TITEL: Kontroll av bultar i huvudrotorväxel

GÄLLER: Alla MDHC modell 369D, 369E och 369F/FF

90-24-07 MCDONNELL DOUGLAS HELICOPTER COMPANY (MDHC):

Amendment 39-6784. Docket Number 90-ASW-10.

Figure 1. Inspection/Definition of Bolt Heads.

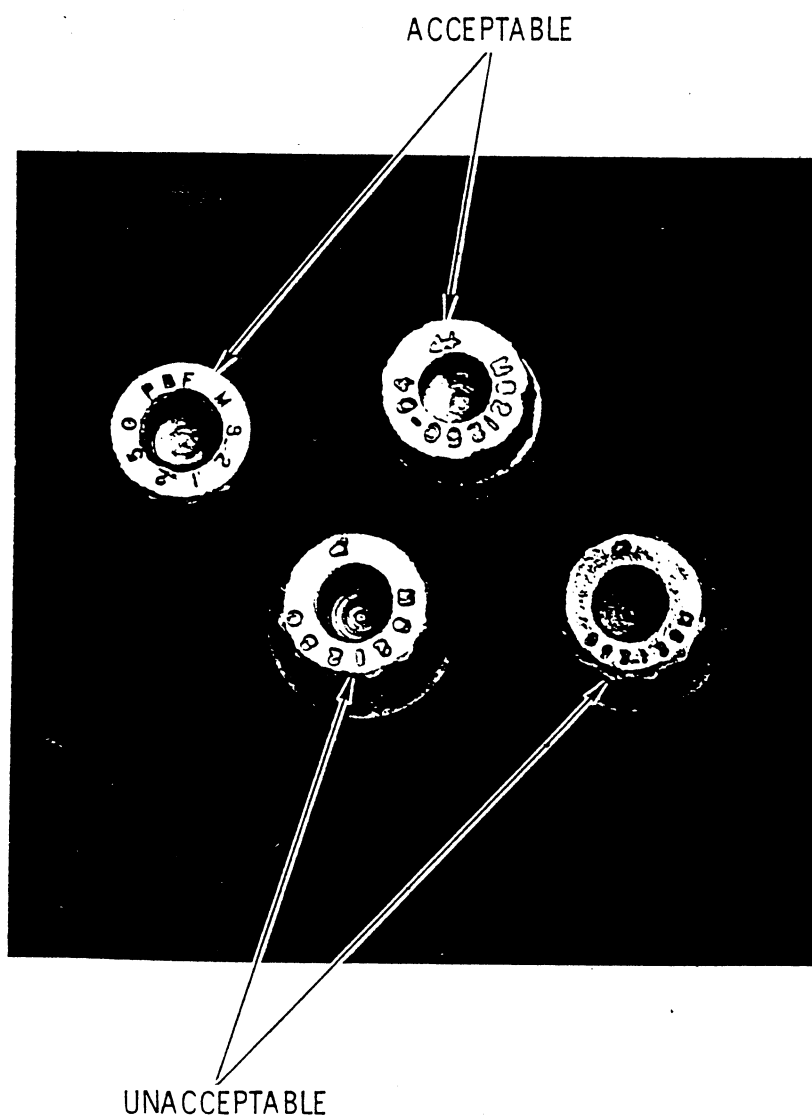
(a) Within the next 300 hours' time in service after the effective date of the AD or at the next annual inspection or the next time the transmission is removed, whichever occurs first, after the main rotor transmission is removed inspect the MS21250-04036 bolts which retain the debris cover, P/N 369D25174. Remove any bolts with the head inscription shown as unacceptable in Figure 1, and replace with MS21250-04038 bolts, which have a length of 2.887 plus/minus 0.010 inch.

(b) Inspect the thread protrusion of all bolts. Remove any bolt which does not protrude through the H14-4 nut for a length equivalent to two full threads (0.071 inch minimum), including the chamfer. Replace removed bolts with MS21250-04038 bolts. Torque the bolts to 50-70 inch pounds. Verify that the bolts protrude through the nut for a length equivalent to two full threads (0.071 inch minimum), including the chamfer. If more than four threads protrude through the nut, add AN960C416L or AN960C416 washers under the nut as required. Remove and reinstall parts in accordance with the manufacturer's instructions.
